**ADDENDUM No. 1**

Pine Lake State Park  
Shower Buildings & Cabin Renovation  
Hardin County, IA  
PROJECT NUMBER: 19-02-42-01

April 10, 2020

**SK-3**

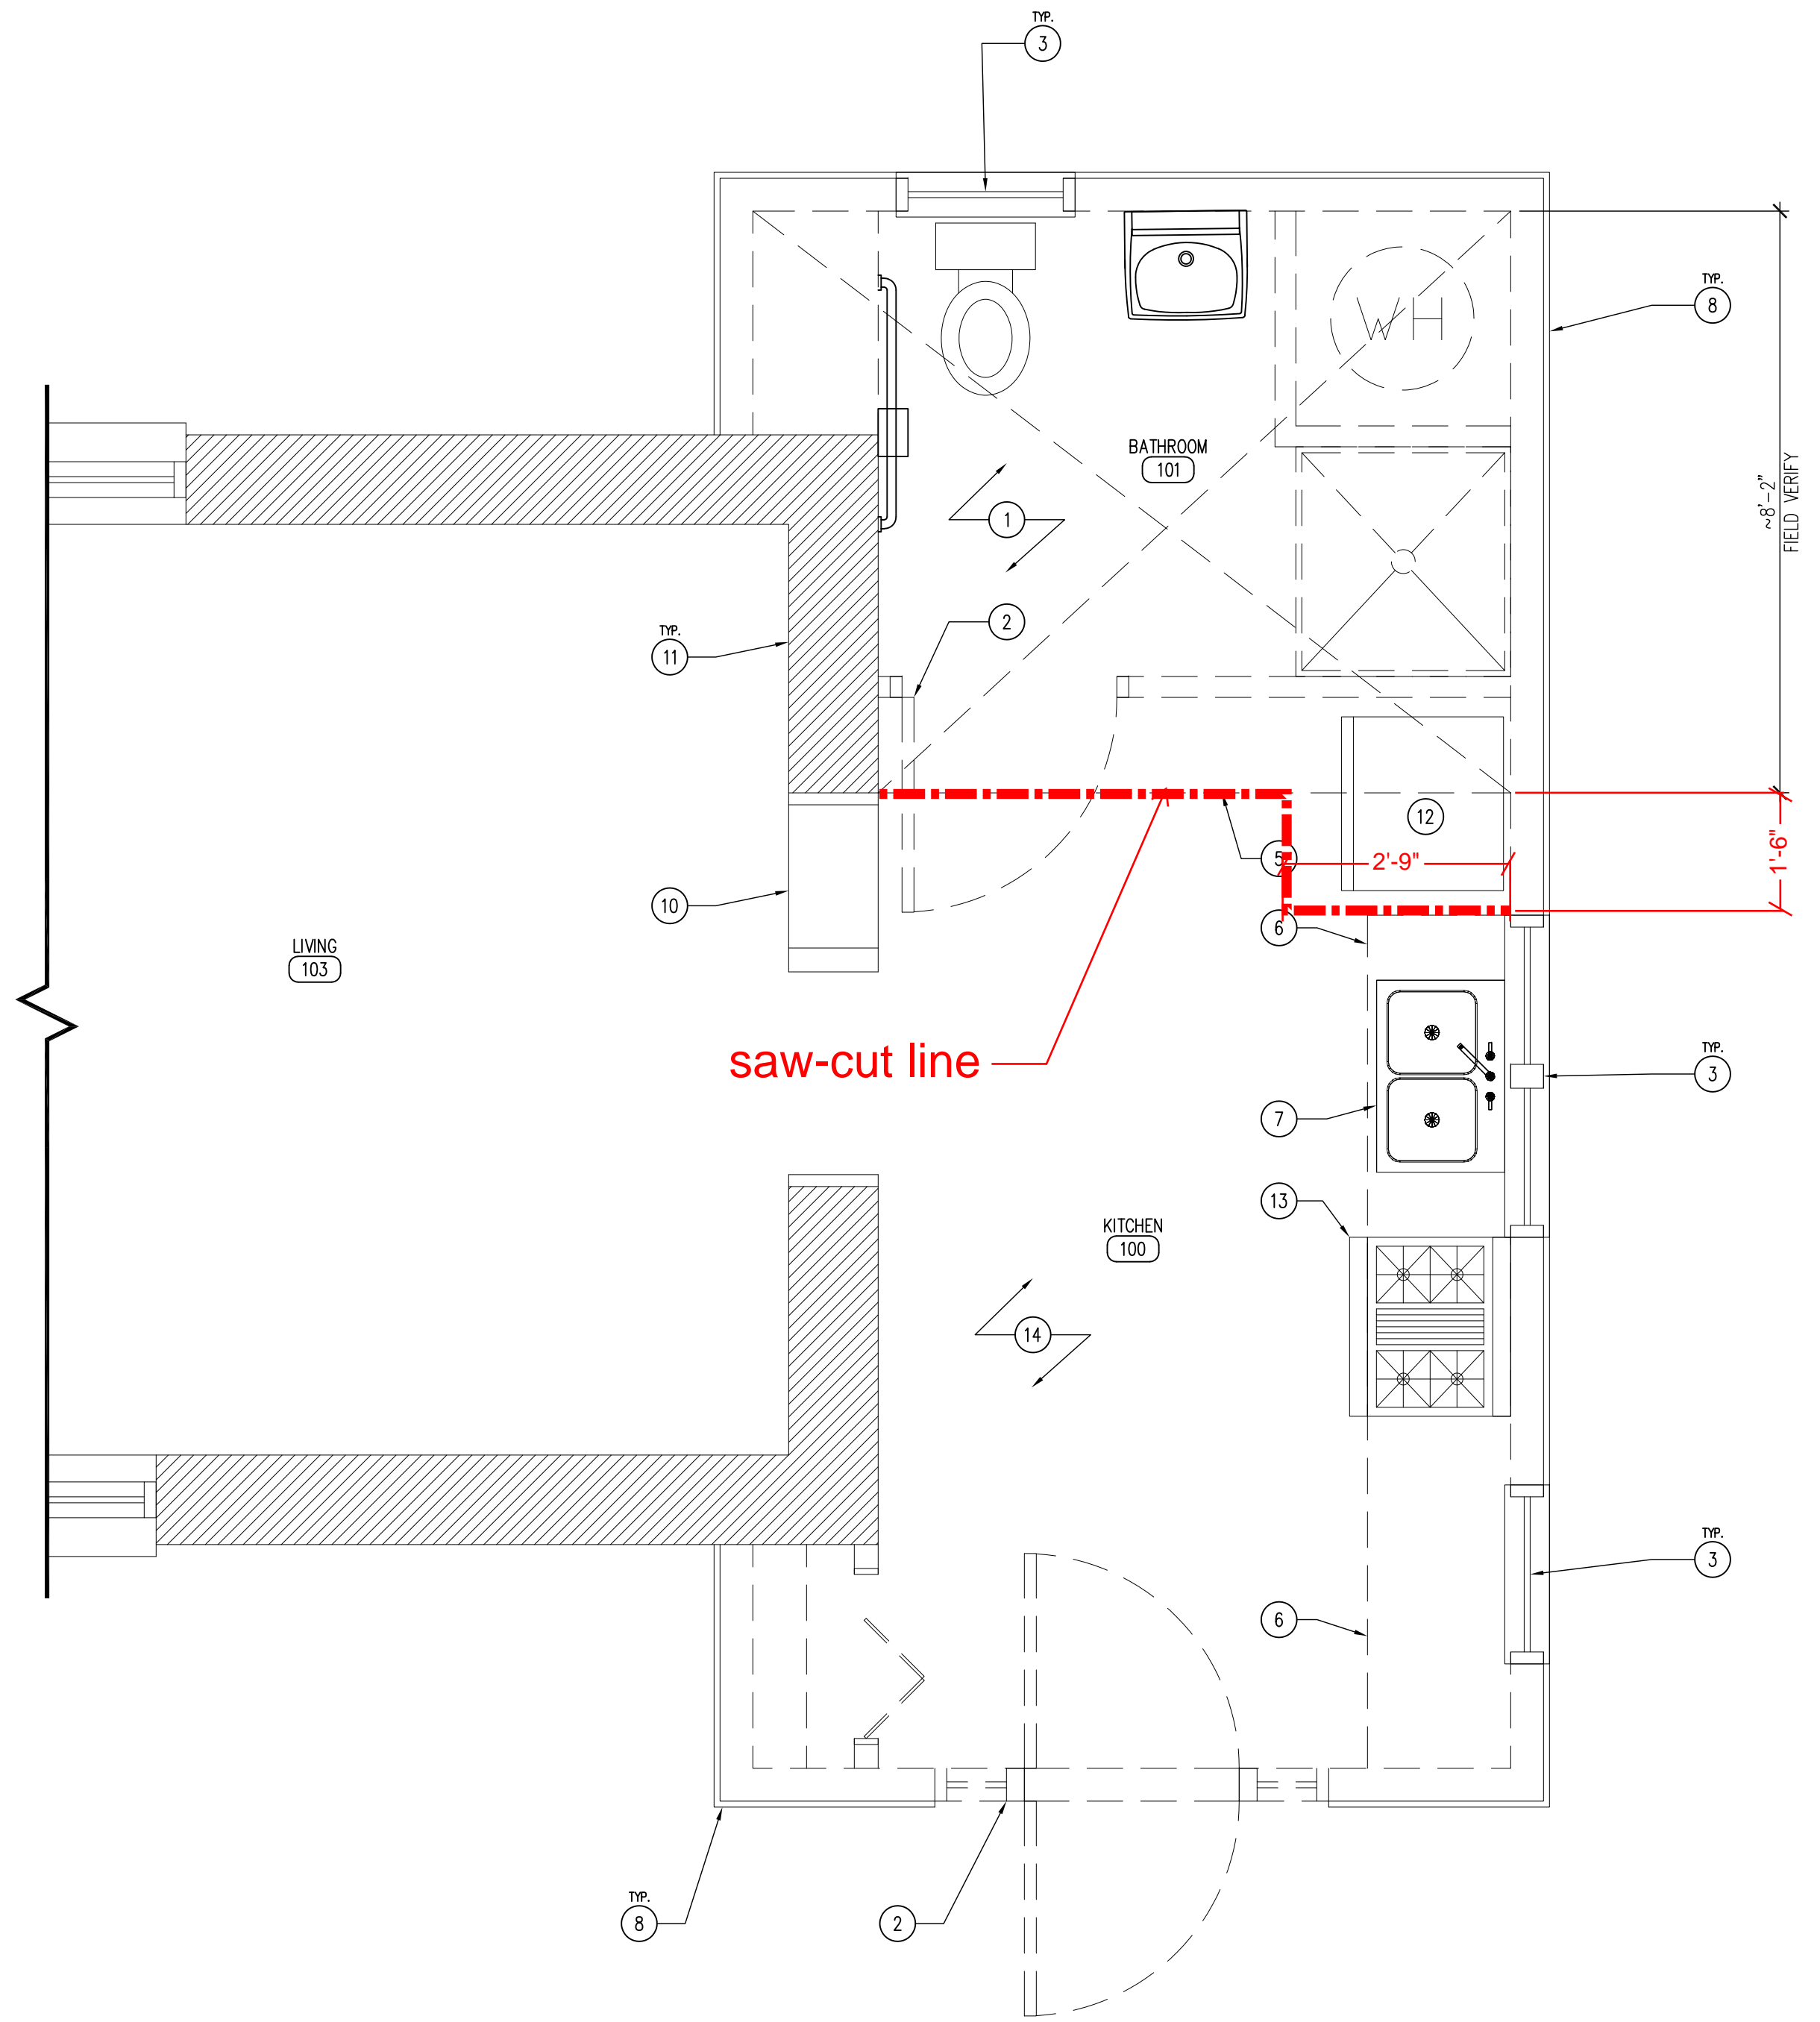
9. Plan sheet A-050 the saw-cut line in the restroom shall be moved to line up with the jog in the wall between the bathroom and kitchen sheet A-100 (see attached sketch SK-3).
